Board of Building and Fire Code Appeals

Meeting Agenda - Final

Staff Report

File #: 25-0233

SHEET:
A-3
 3 OF 3

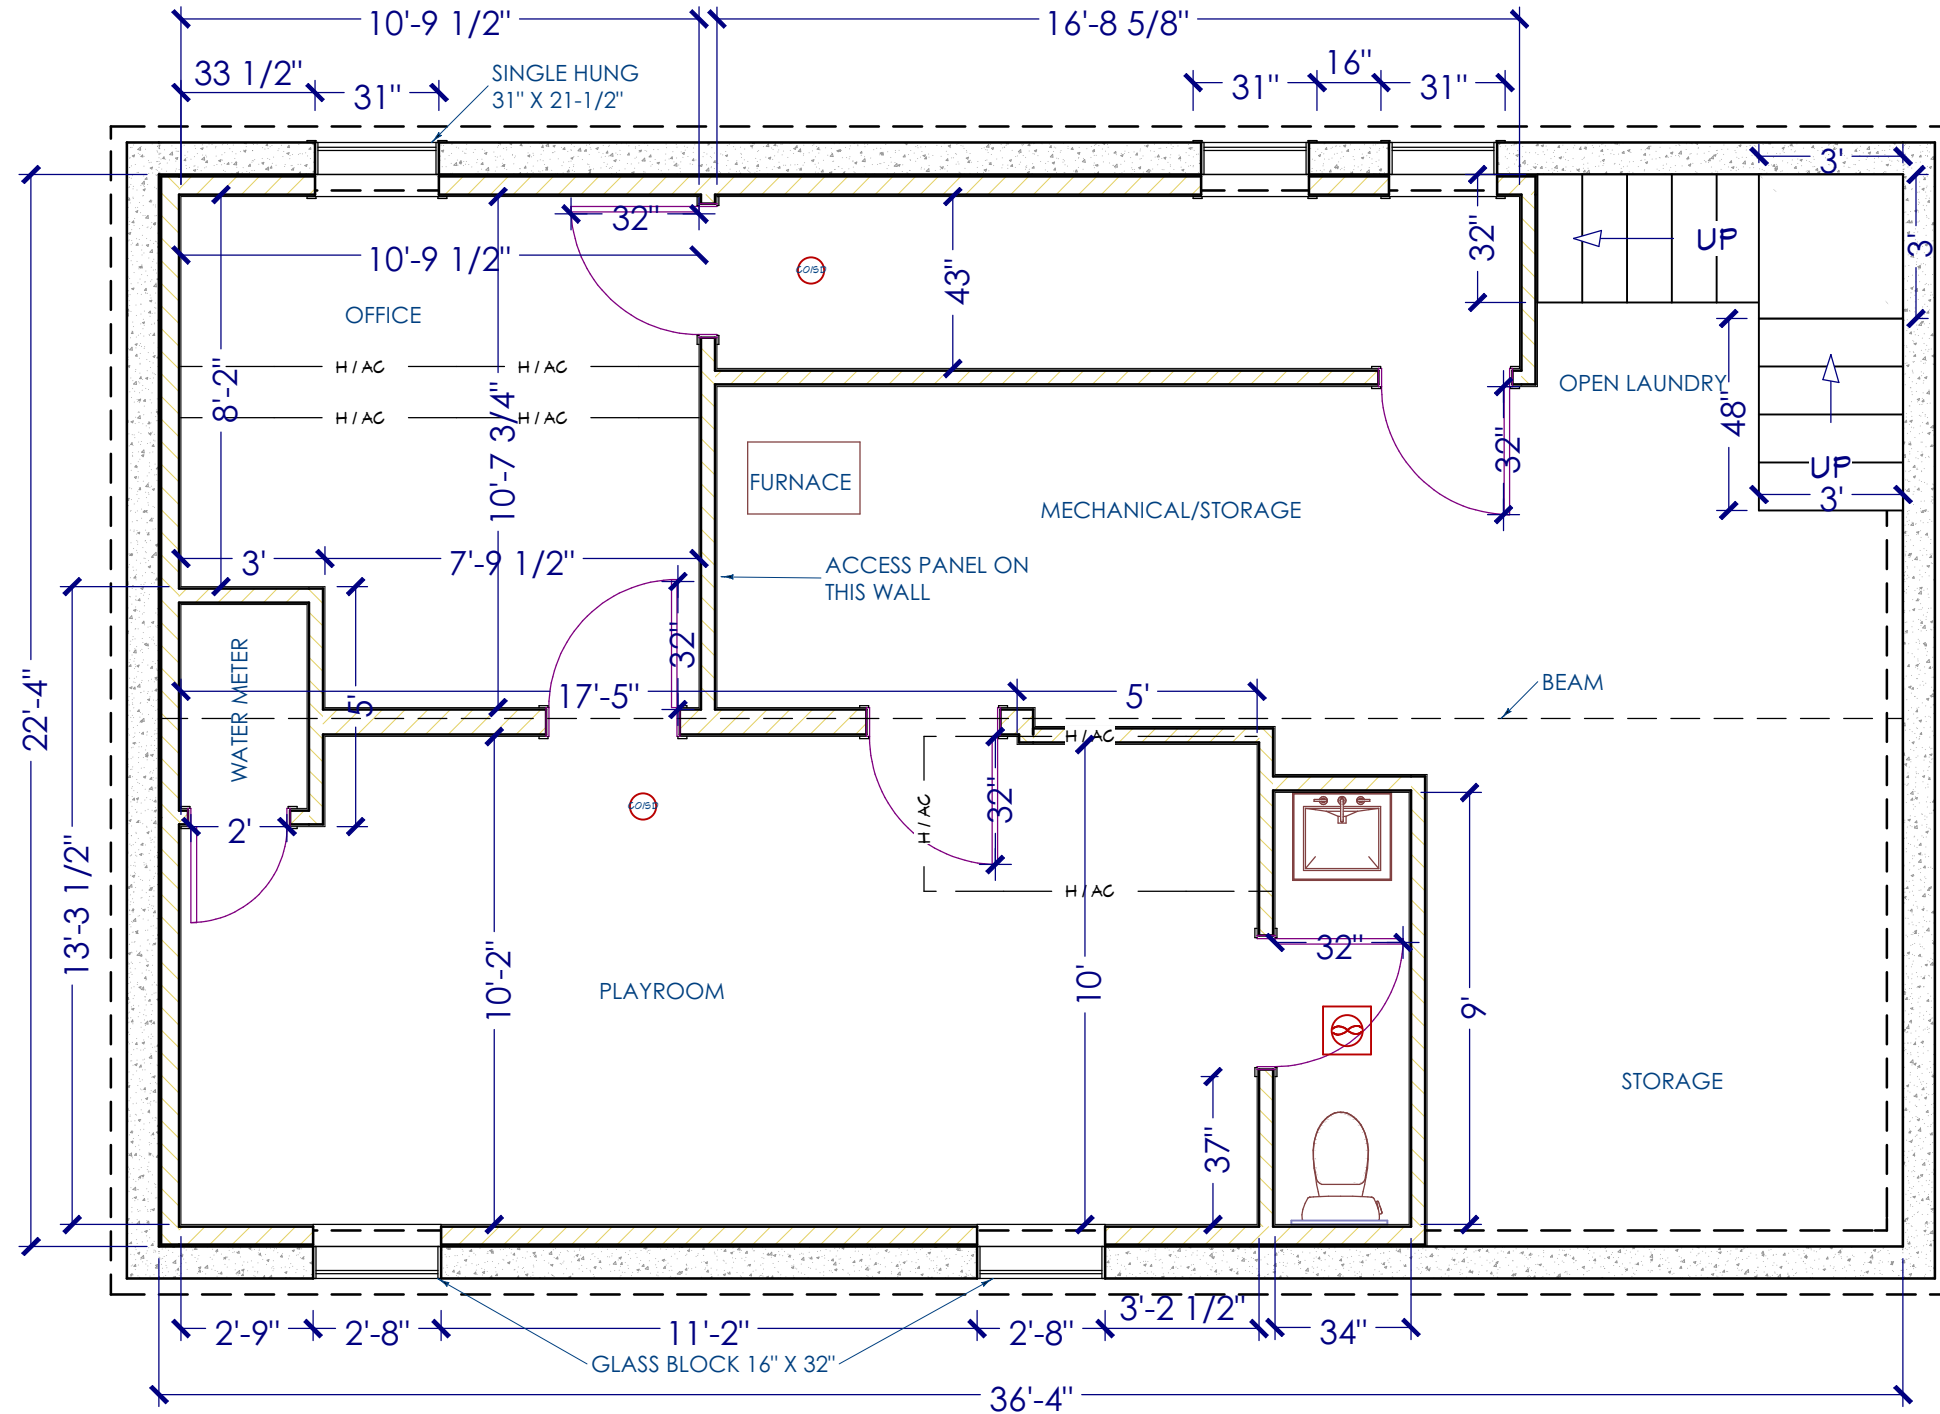
7905 Clarke Street - Kaija Zusevics, is requesting a variance to allow a 32" wide stair width whereas 34" minimum is required; and a variance to allow 67" on a portion of the stairwell headroom whereas 72" minimum is required. Existing stairs for a newly finished basement need to be 34" wide per Wisconsin Uniform Building Code Section 30.55(7)(a)(1). The existing staircase is too narrow to support a newly finished basement, even with these reduced clearance requirements for houses built prior to 1980.

7905 Clarke Street – Kaija Zusevics, is requesting a variance to allow a 32” wide stair width whereas 34” minimum is required; and a variance to allow 67” on a portion of the stairwell headroom whereas 72” minimum is required. Riser height & Tread depth not provided. Existing stairs for a newly finished basement need to be 34” wide per Wisconsin Uniform Building Code Section 30.55(7)(a)(1). The existing staircase is too narrow to support a newly finished basement, even with these reduced clearance requirements for houses built prior to 1980.

1. Existing stairways shall conform to the following: (Note: A new, relocated or reconfigured stairway shall conform to the requirements of Section SPS 321.04.)
 - a. Riser height shall be eight and one quarter (8-¼) inch maximum.
 - b. Tread depth shall be eight and one half (8-½) inch minimum.
 - c. Headroom shall be seventy-two (72) inches minimum.
 - d. Stair width shall be thirty-four (34) inches minimum.
 - e. Handrails and guardrails shall be installed in accordance with Section SPS 321.04(3). Exception: Existing handrails and guardrails do not require modifications unless the stairway is new, relocated or reconfigured. In such conditions, the handrails and guardrails shall conform to the requirements of Section SPS 321.04.
 - f. Stairway landings shall have minimum dimensions of thirty-four (34) inches by thirty-four (34) inches.

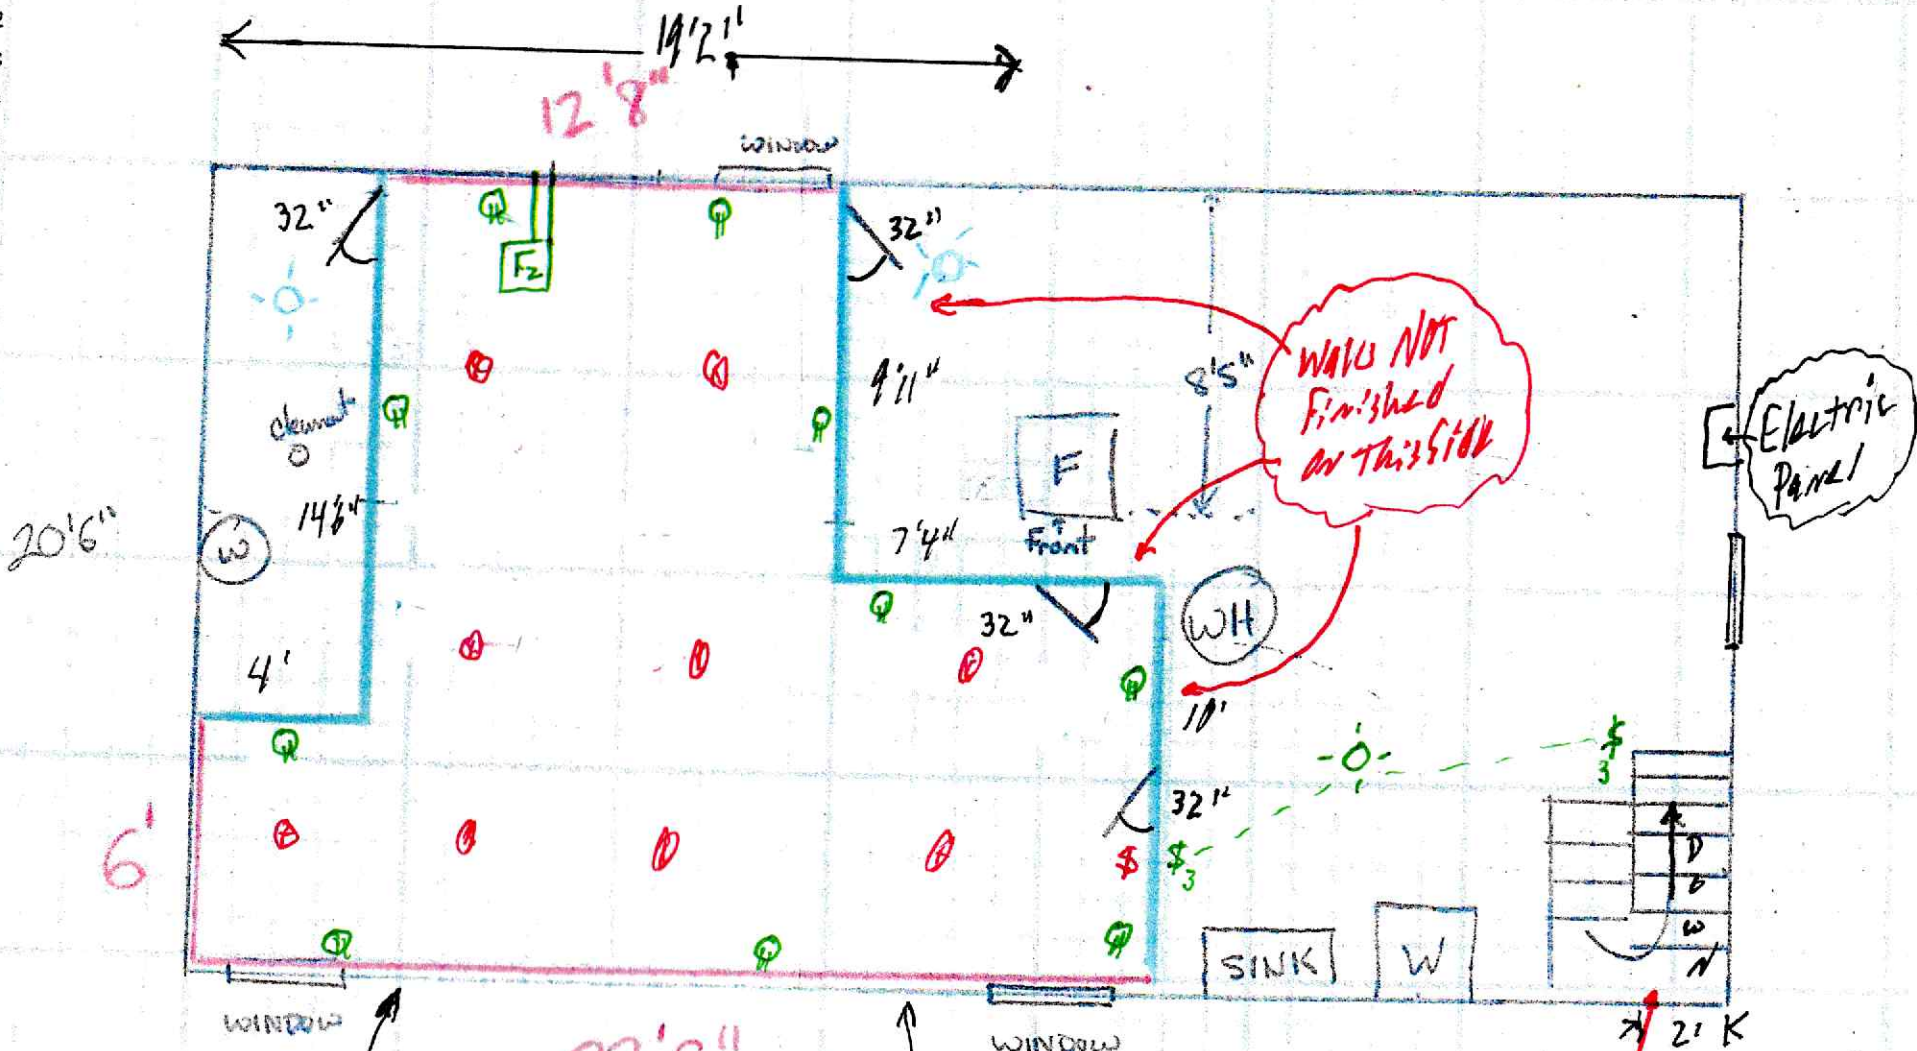
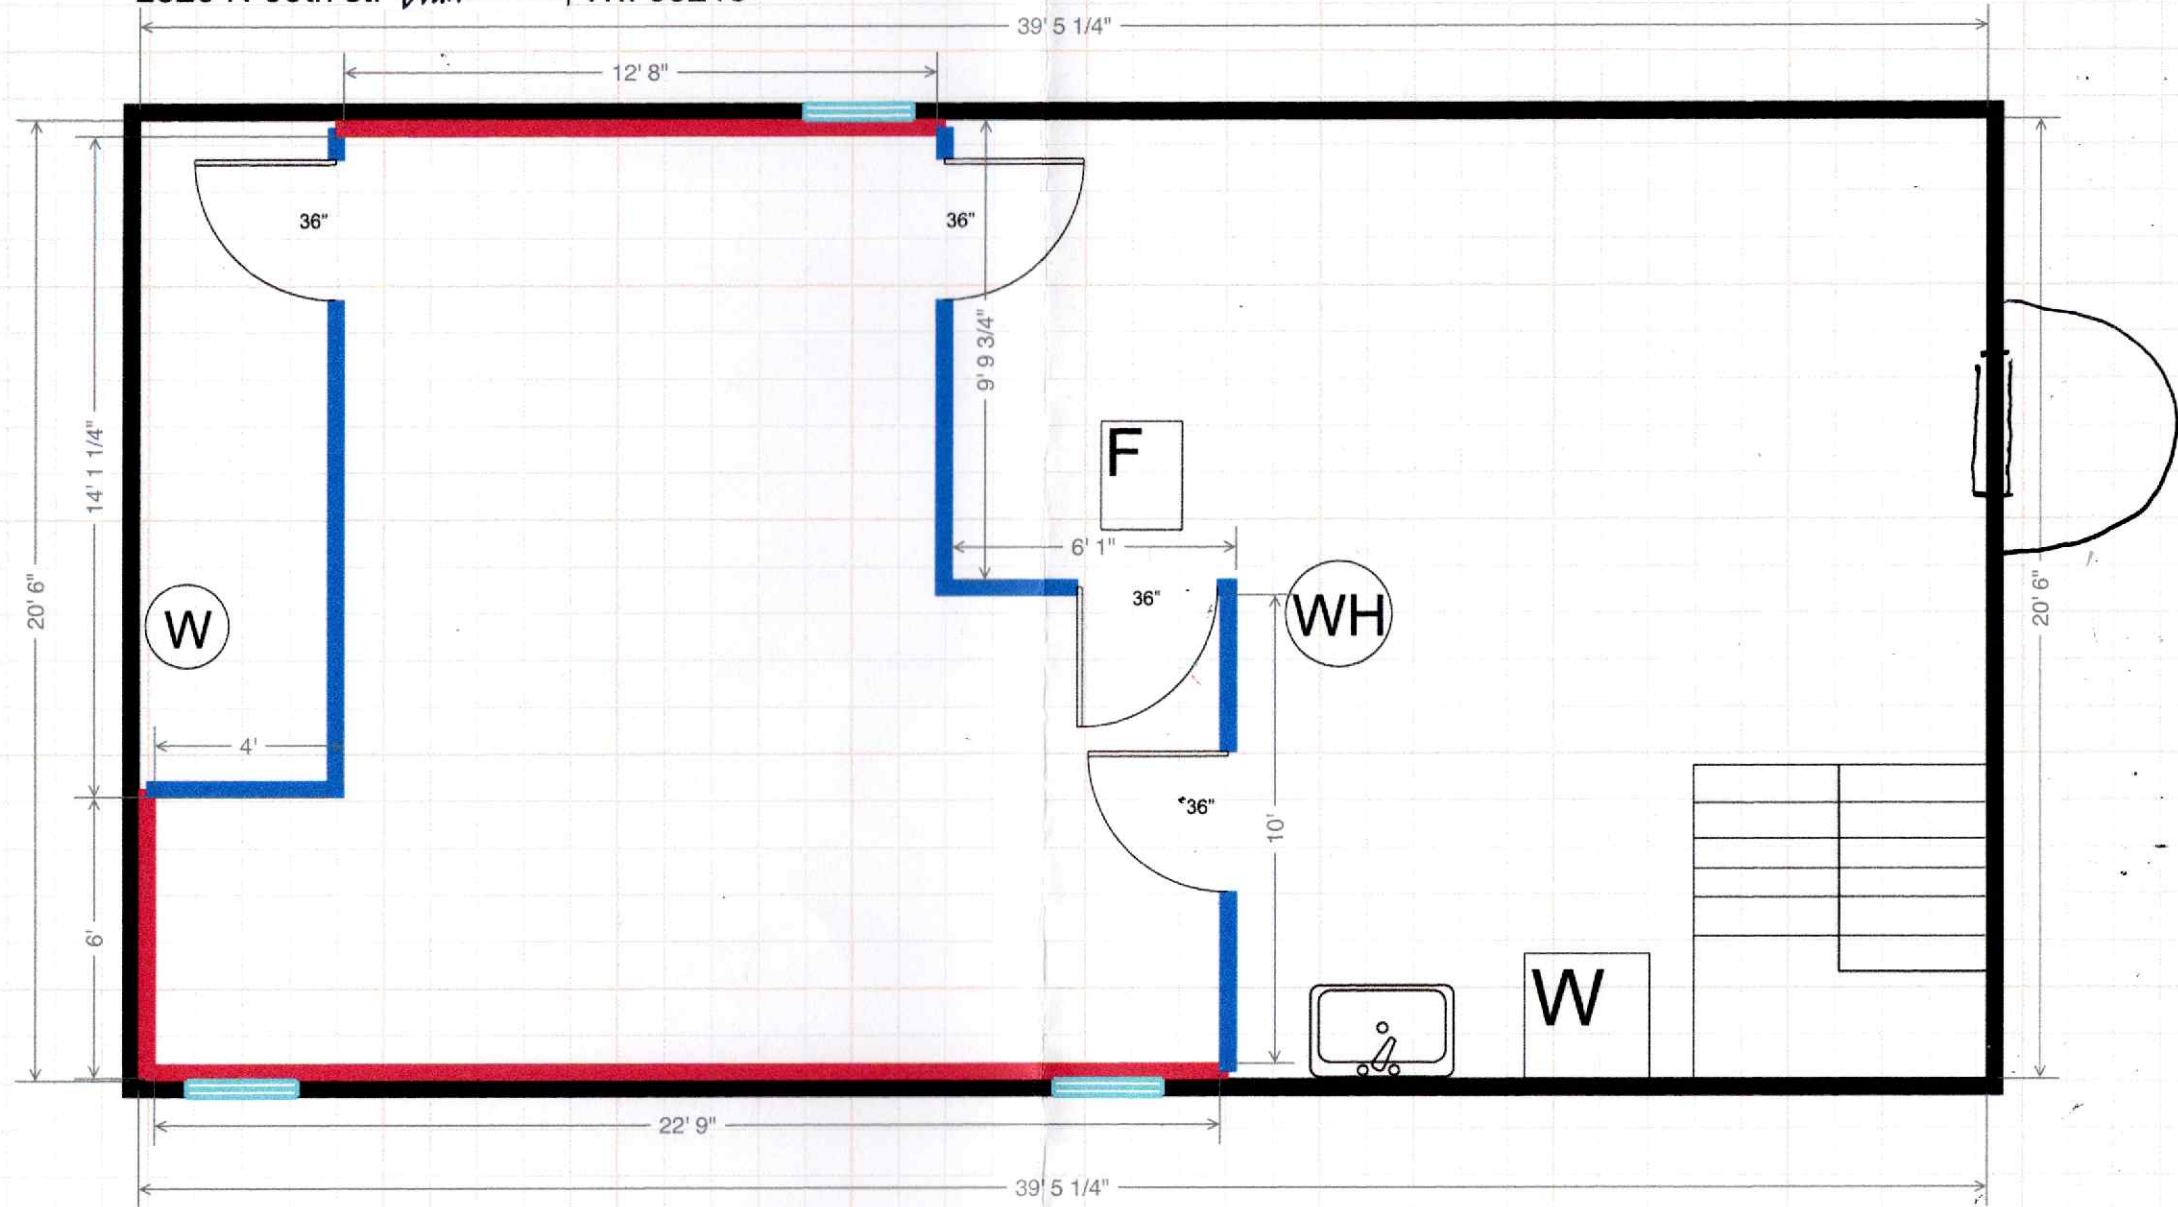
2320 N 69th Street - Shawn & Megan Slattery, are requesting a variance to allow a 24" wide stair width whereas 34" minimum is required; Riser height provided is 9" whereas 8.25 max is required. Landing & Stair headroom dimension were not provided. Existing stairs for a newly finished basement need to be 34" wide per Wisconsin Uniform Building Code Section 30.55(7)(a)(1). The existing staircase is too narrow to support a newly finished basement, even with these reduced clearance requirements for houses built prior to 1980.

2320 N 69th Street – Shawn & Megan Slattery, are requesting a variance to allow a 24” wide stair width whereas 34” minimum is required; Riser height provided is 9” whereas 8.25 max is required. Landing & Stair headroom dimension were not provided. Existing stairs for a newly finished basement need to be 34” wide per Wisconsin Uniform Building Code Section 30.55(7)(a)(1). The existing staircase is too narrow to support a newly finished basement, even with these reduced clearance requirements for houses built prior to 1980.

1. Existing stairways shall conform to the following: (Note: A new, relocated or reconfigured stairway shall conform to the requirements of Section SPS 321.04.)
 - a. Riser height shall be eight and one quarter (8-¼) inch maximum.
 - b. Tread depth shall be eight and one half (8-½) inch minimum.
 - c. Headroom shall be seventy-two (72) inches minimum.
 - d. Stair width shall be thirty-four (34) inches minimum.
 - e. Handrails and guardrails shall be installed in accordance with Section SPS 321.04(3). Exception: Existing handrails and guardrails do not require modifications unless the stairway is new, relocated or reconfigured. In such conditions, the handrails and guardrails shall conform to the requirements of Section SPS 321.04.
 - f. Stairway landings shall have minimum dimensions of thirty-four (34) inches by thirty-four (34) inches.
